6,879,798 B2

IMAGE FORMING APPARATUS

REQUEST FOR CERTIFICATE OF CORRECTION OF PATENT FOR APPLICANT'S MISTAKE (37 C.F.R. § 1.323)

SUBSTITUTE AMENDMENT AFTER ALLOWANCE UNDER 37 C.F.R. § 1.312

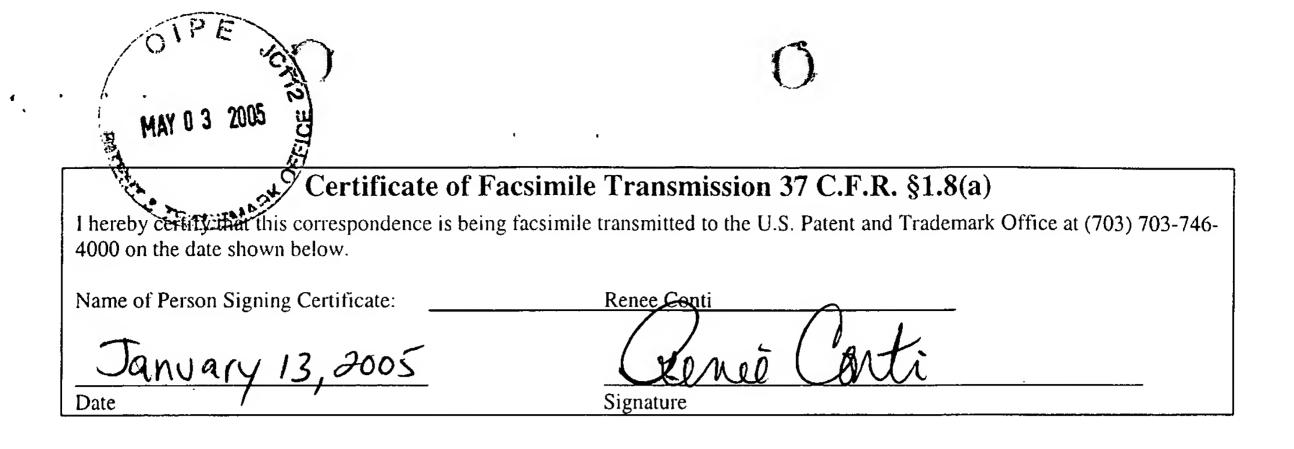
At column 10, line 28: $A=\{(D1 - D2)/D1\}x100\%$ should read $A=\{(D2 - D1)/D1\}x100 - \cdots$;
